**PROJECT: WASHINGTON ST., VISTA DR. TO THIRD AVE.
IMPROVEMENT PROJECT # ST2014-04**

ADDENDUM NO. 2
To the Contract Provisions for
CITY OF FERNDALE, WASHINGTON

Washington St., Vista Dr. to Third Ave. Improvement Project
ST2014-04

WASHINGTON STREET
VISTA DR. TO THIRD AVENUE PROJECT
TESC AND DEMO PLAN STA 6+00 - 12+00

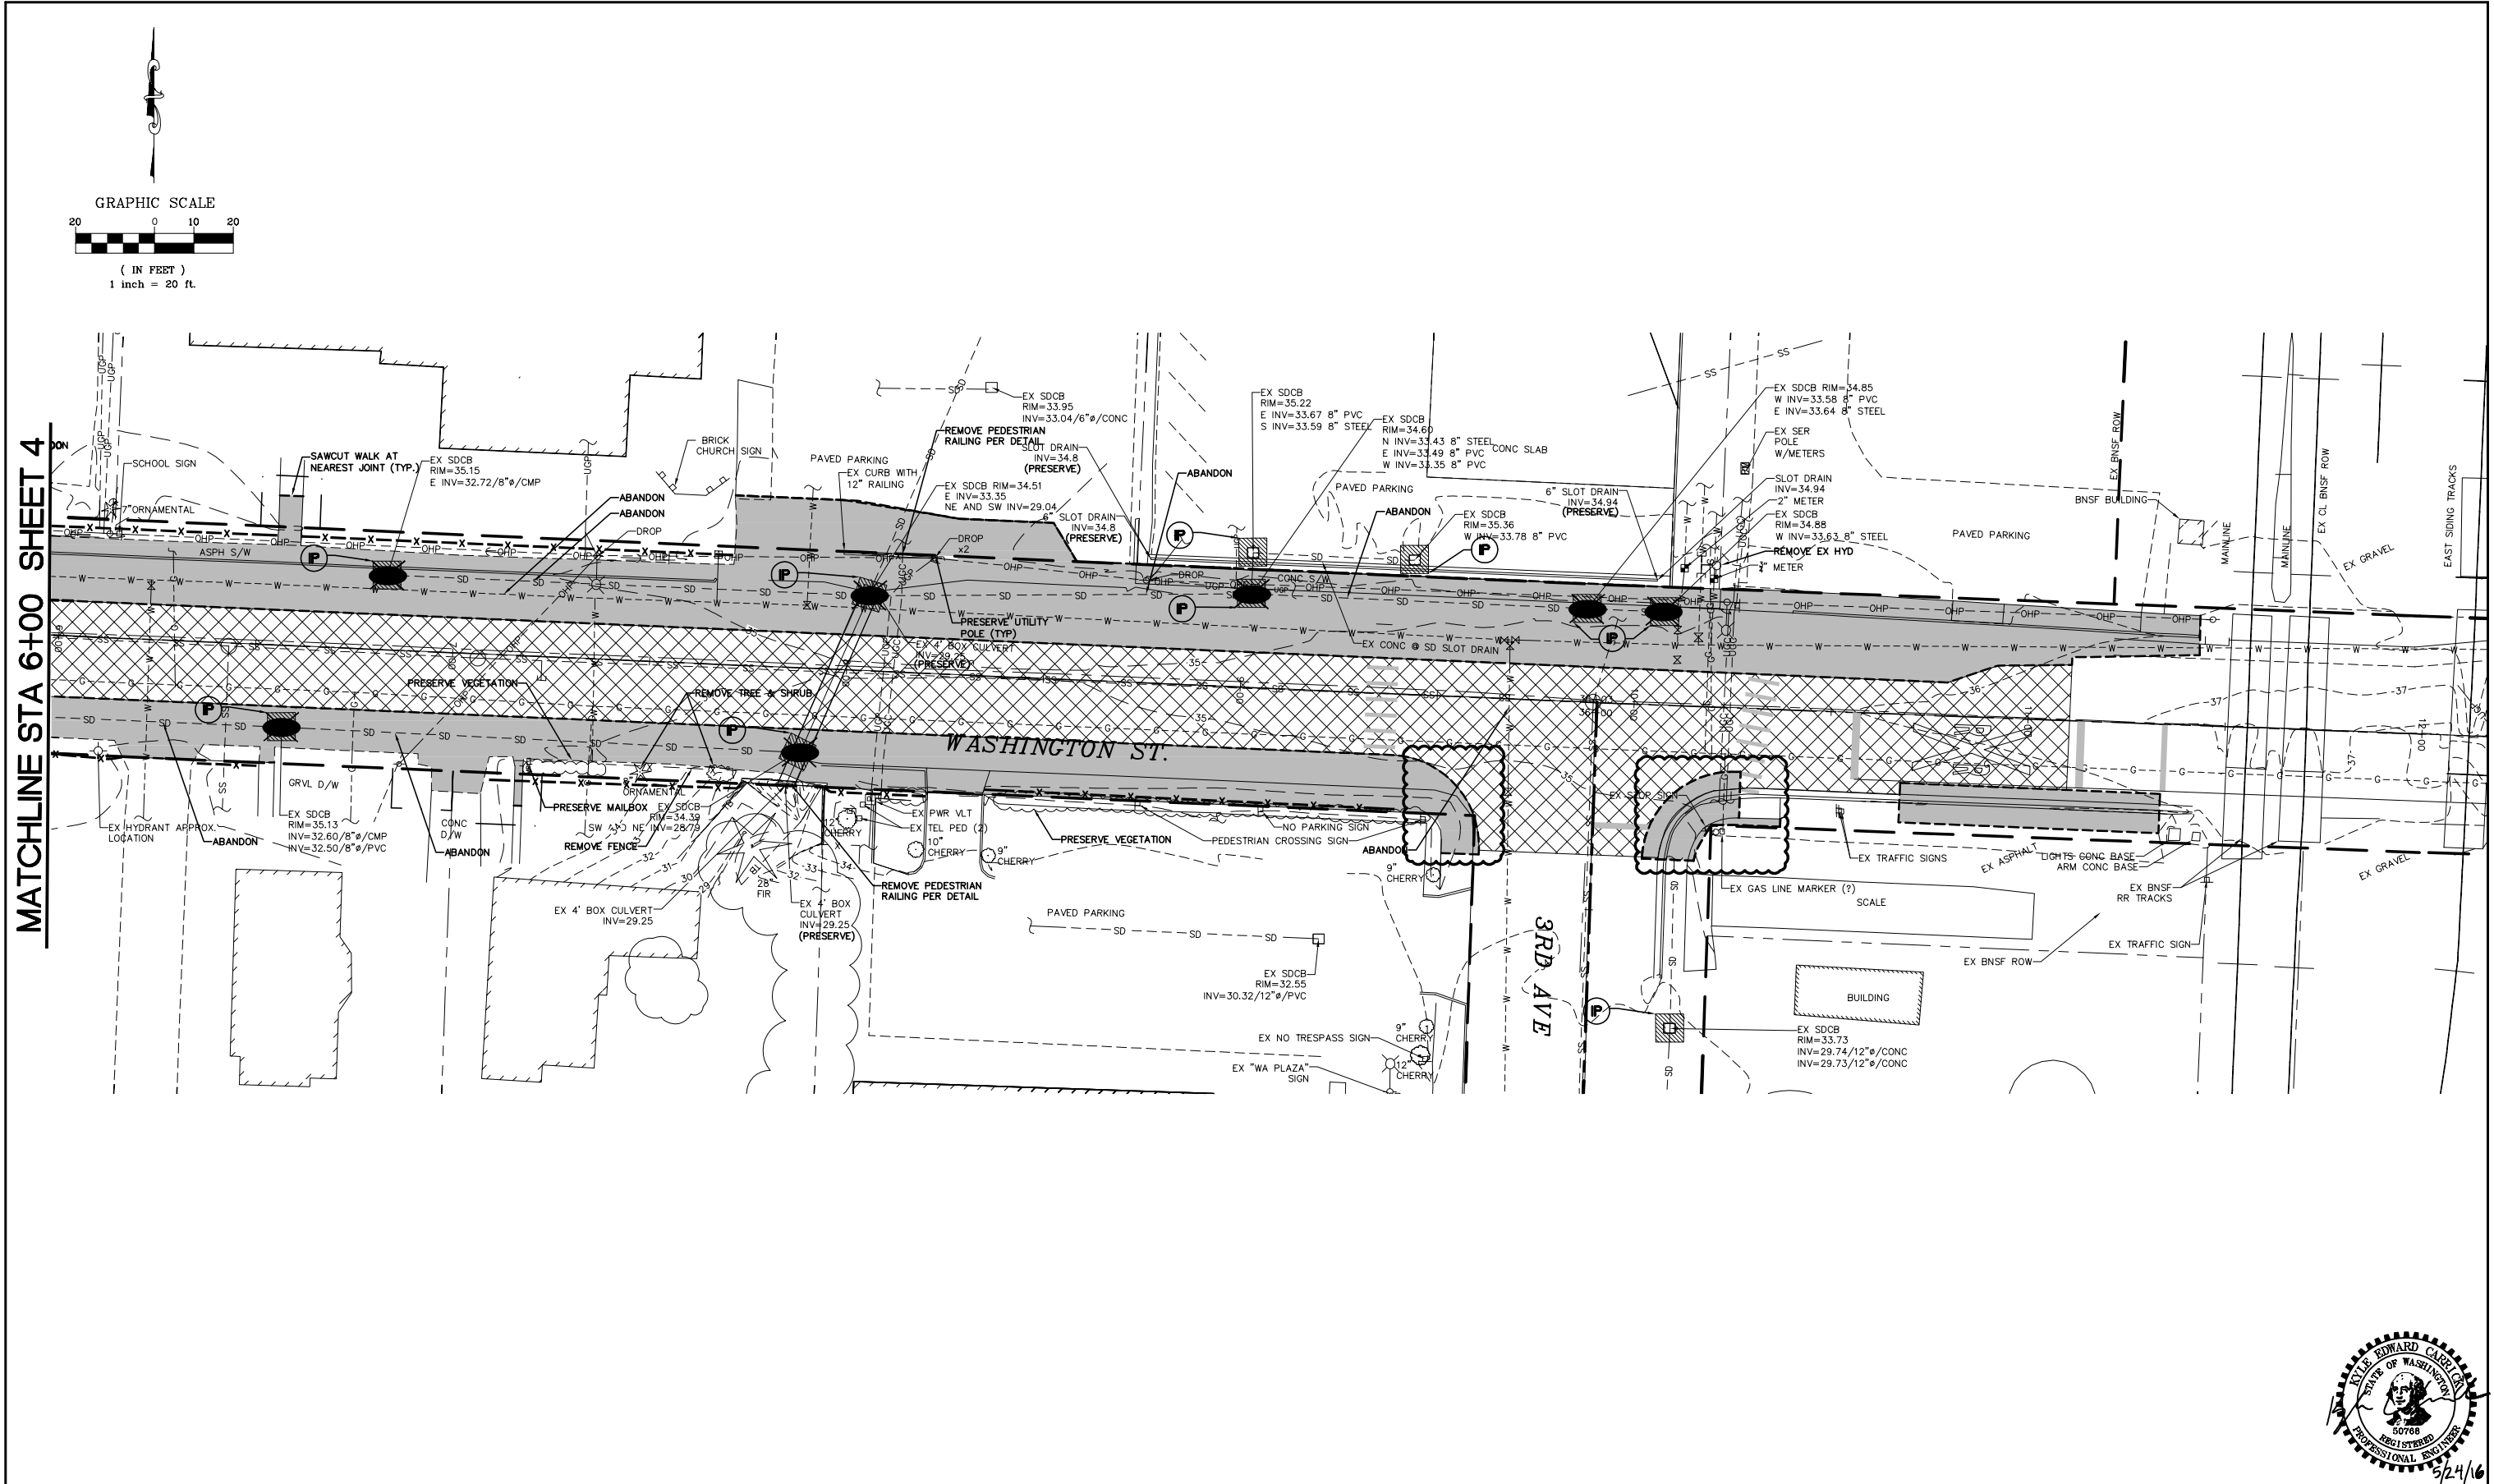
- Plan Sheet 5. The demo areas at the intersection of Washington and 3rd were changed.
- Plan Sheet 8, 10, and 13. ADA ramps were added at the intersection of Washington and 3rd.
- Plan Sheet 9. Approximately STA 5+01 RT. 4" service changed to 3" service.
- Plan Sheet 12. ADA ramps were added at the intersection of Washington and 3rd and signs No. 8 and No. 9 were deleted.
- Plan Sheet 15. The Water Service Connection Detail is revised.

CITY OF FERNDALE 3" METER INSTALLATION

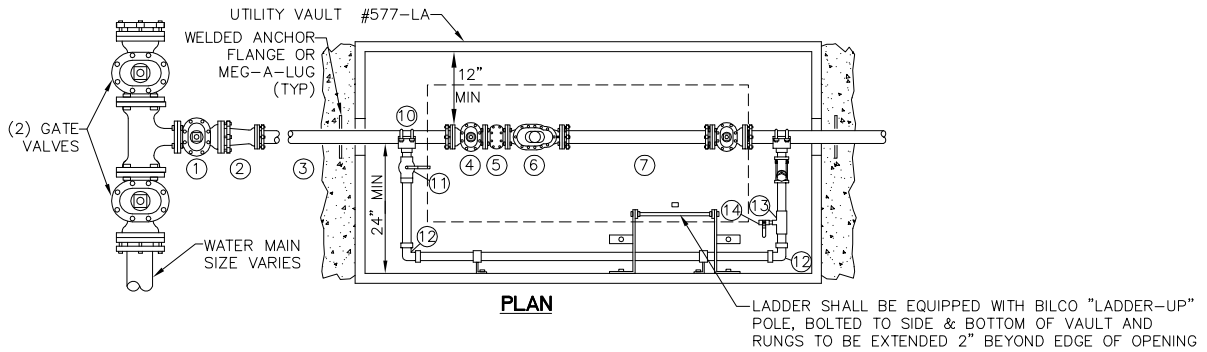
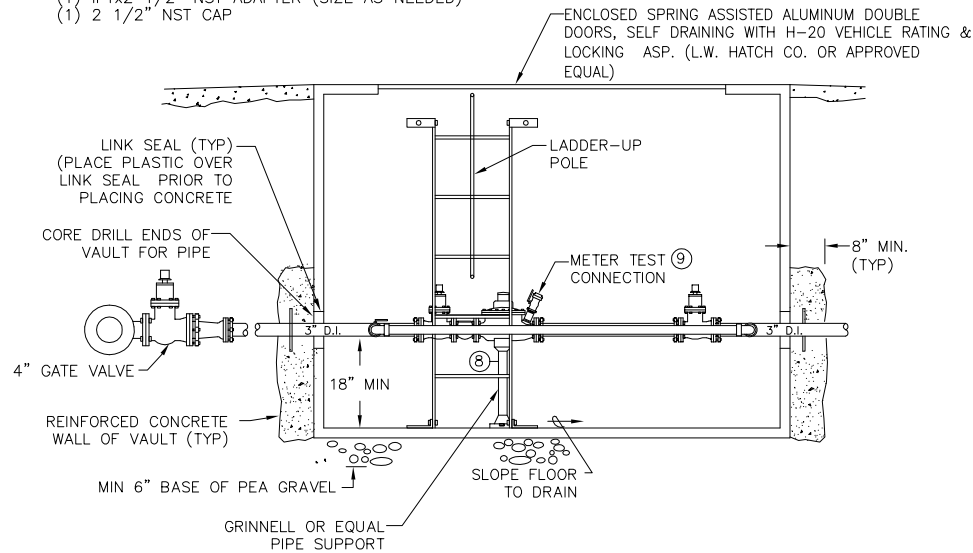
The 4 In. Diam. Service Connection Detail issued under Addendum 1 is deleted and replaced with the attached 3 In. Diam. Service Connection Detail.

SIDEWALK RAMP TYPE PARALLEL A (MODIFIED)

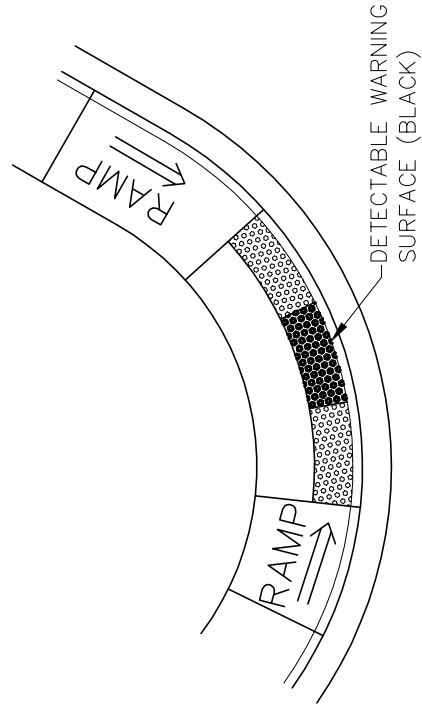
The attached Sidewalk Ramp Type Parallel A (Modified) Detail is added to the Contract Documents.
